Bulletin No: L047 Issued: 101230

3 MT Swivel Cap Bolt and Seal Conversion Kit - PA8180:

This Kit pertains only to Models 26A058, 26A059, 26A082, 26A086, 26A087, and 26A092 UNIHOOK™

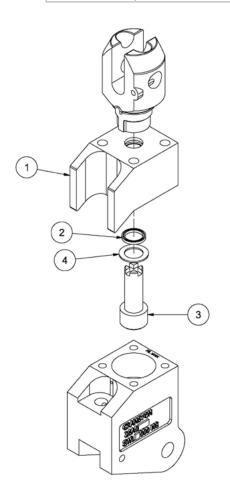
- 1. Remove the existing tie bolts that connect the top cap to the hook body.
- 2. Remove the existing swivel bolt and swivel bolt washer and discard.
- 3. Install the new U Cup Seal, Item 2, into the groove in the bore of the new Top Cap, Item 1. Make sure the legs of the U point upwards.
- 4. Install the new Swivel Bolt, Item 3, and Swivel Bolt Washer, Item 4 through the Top Cap and into the existing Swivel.
- 5. Reinstall the tie bolts through the Top Cap and into the Hook Body.
